**NOTICE OF ADDENDUM
ADDENDUM NO. 2**

**CONTRACT NO. 7939
MADISON MUNICIPAL BUILDING - RENOVATION**

This addendum is issued to modify, explain or correct the original Drawings, Specifications, or Contract Documents and is hereby made a part of the contract documents.

**EXHIBIT E
 A620**

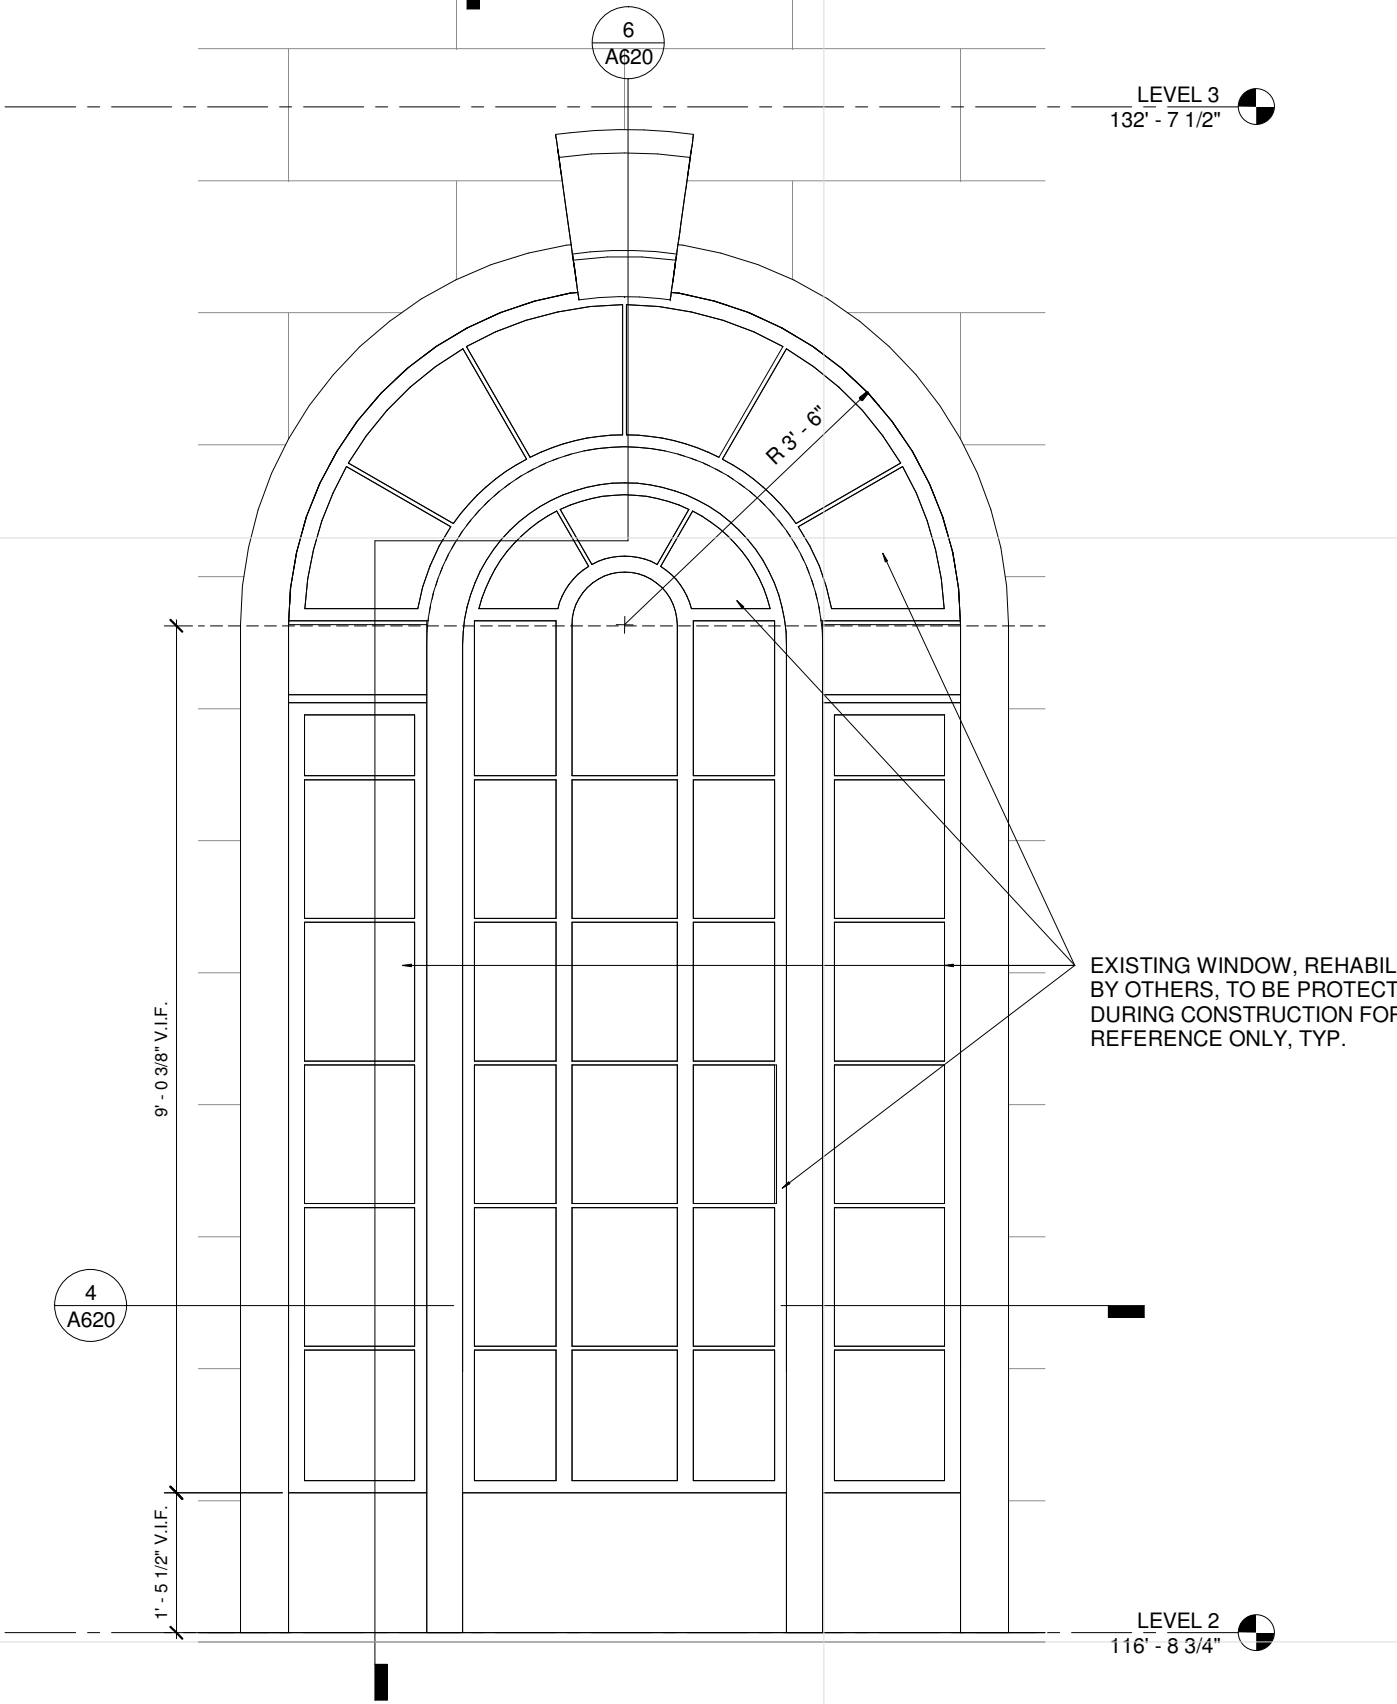
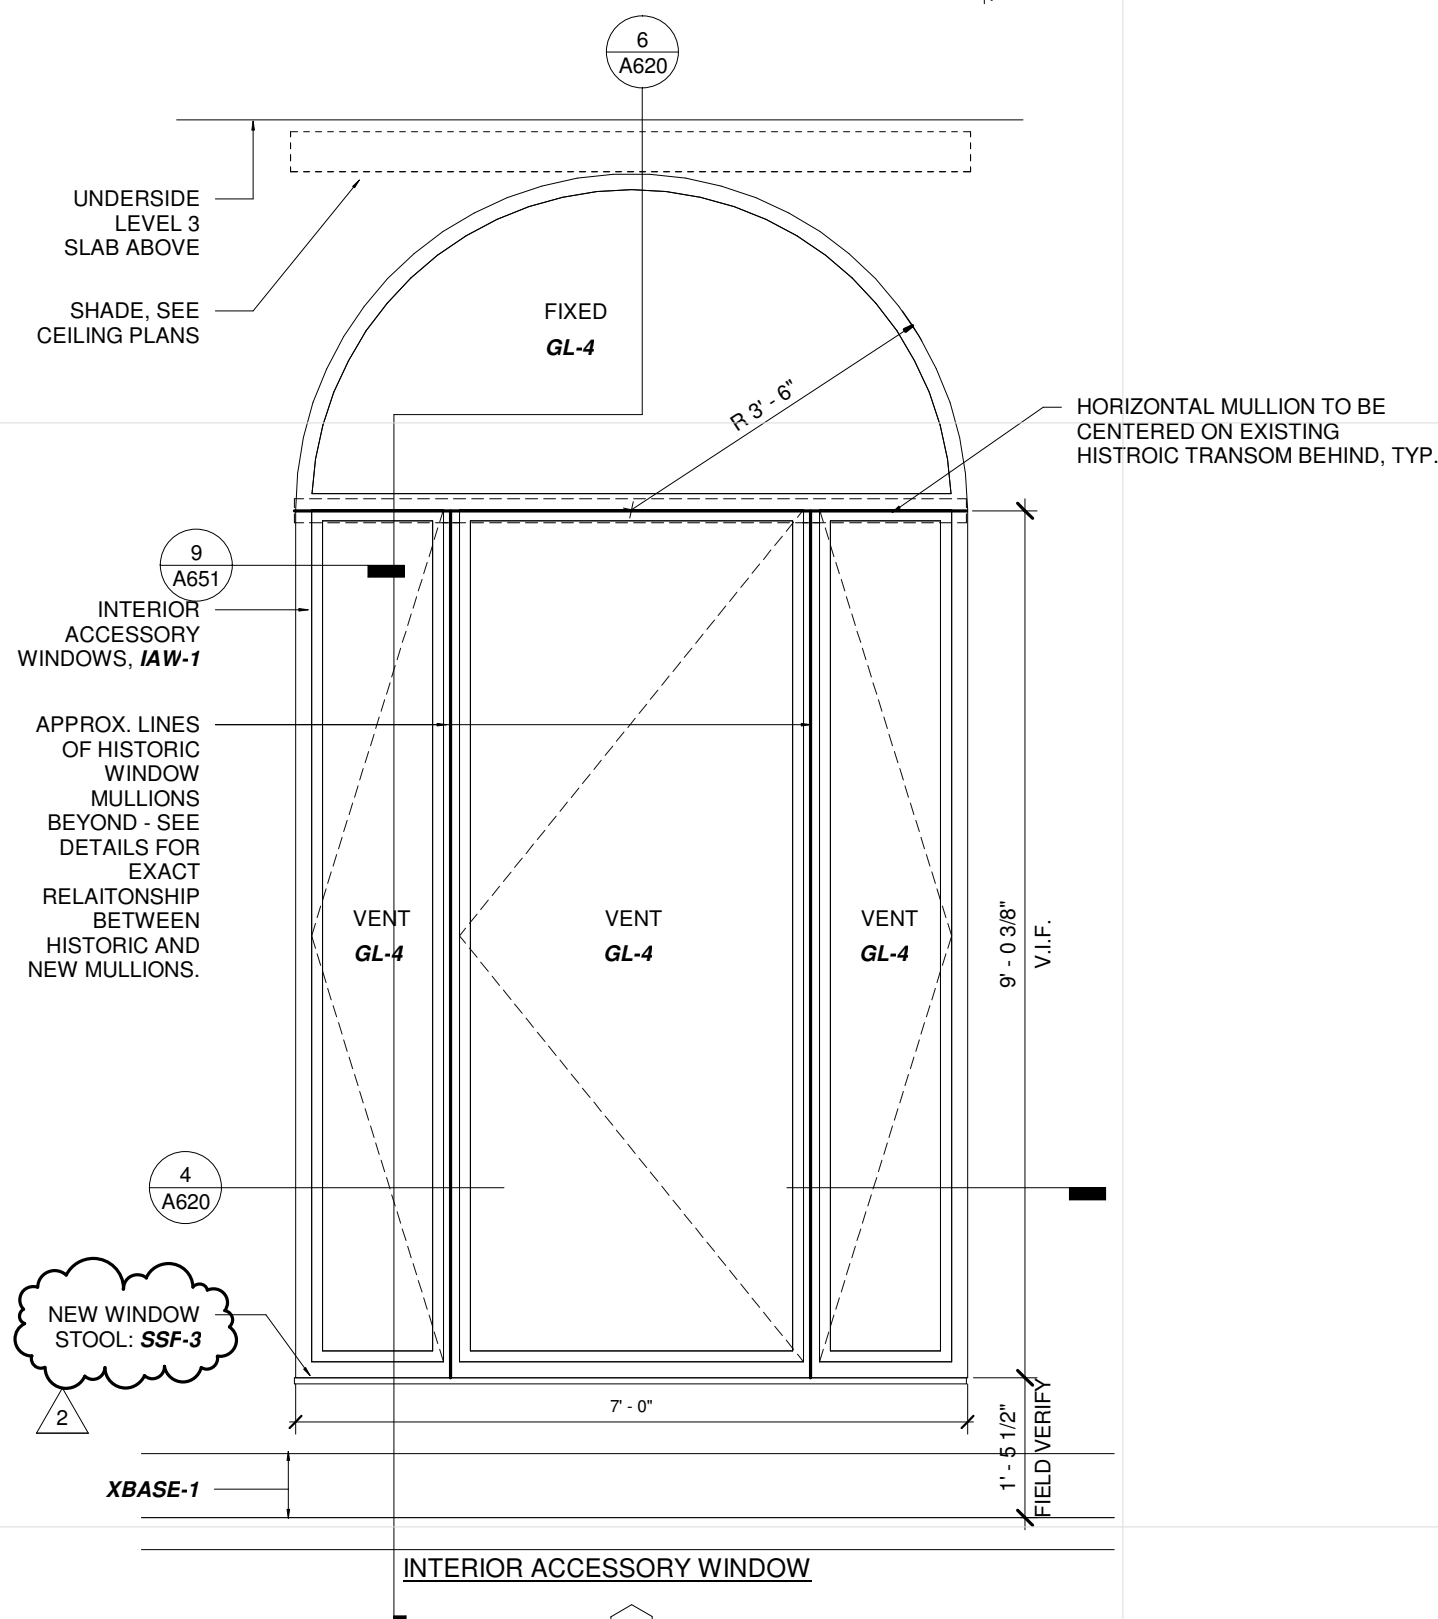
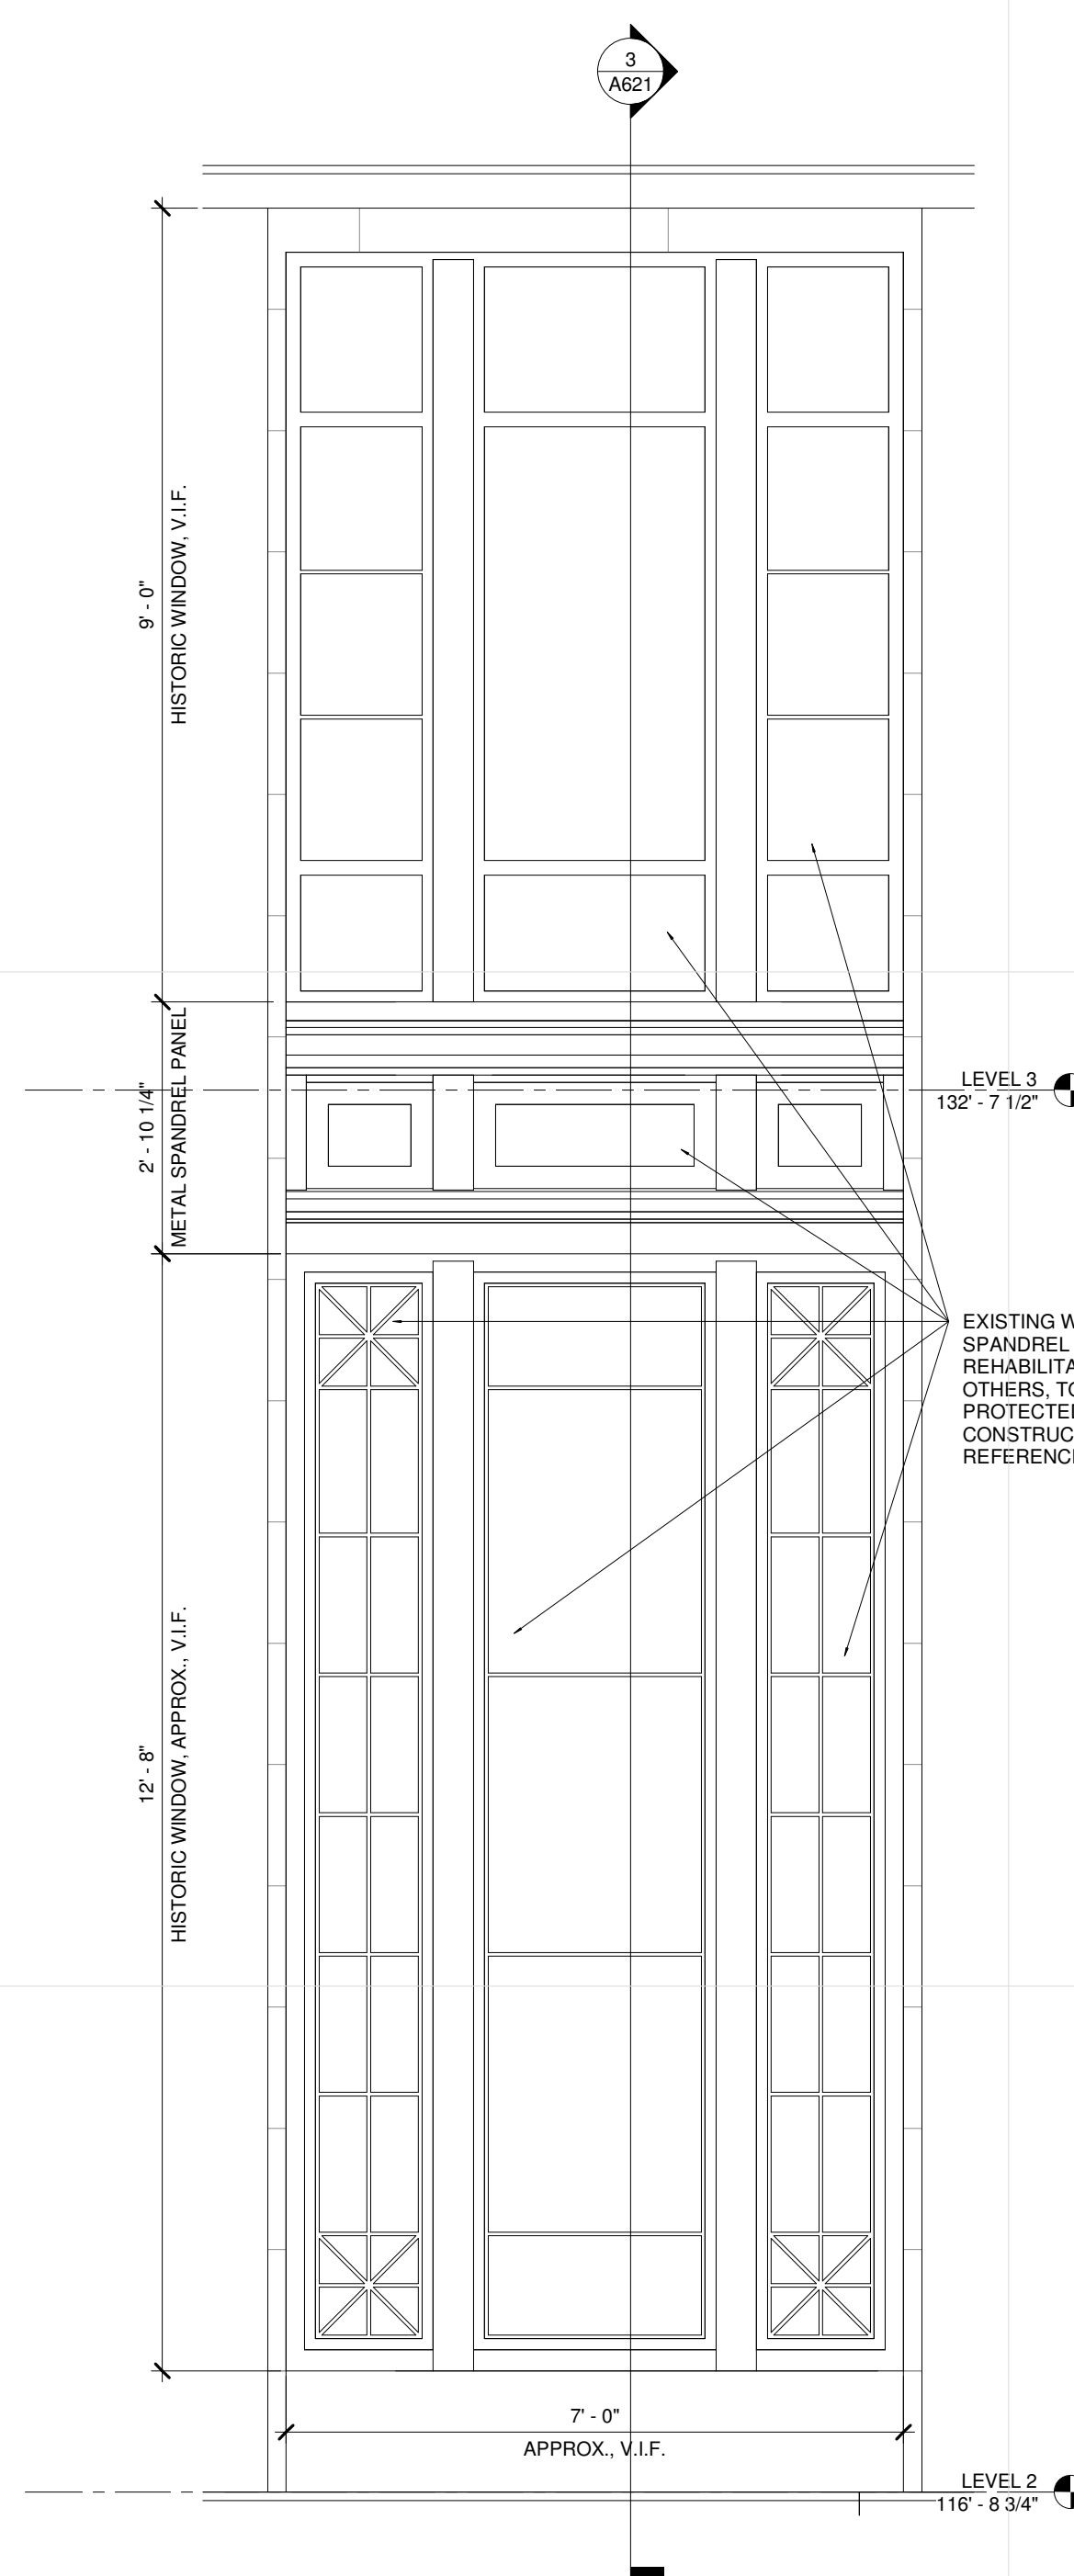
4. Details A620 through A624, and A651 through A654. Due to durability and cost concerns regarding the new metal window stools, these have been changed from MTL-3 to solid surface material SSF-3.
5. BE001. Amend general note 10 on sheet BE001 (drawing); Add language to general note 16 on sheet BE001 (drawing)
6. BE219. Revised stone numbers
7. BE338. See Clarifications Section below
8. BE356. See Clarifications Section Below
9. BE356.1. See Clarifications Section Below
10. BE356.2. See Clarifications Section Below
11. S101. See Structural Memo Attached.
12. S102. See Structural Memo Attached.
13. S103. See Structural Memo Attached.
14. S104. See Structural Memo Attached.
15. S190. See Structural Memo Attached.
16. S201. See Structural Memo Attached.
17. S302. See Structural Memo Attached.
18. S304. See Structural Memo Attached.
19. E300. See MEP Memo Attached.
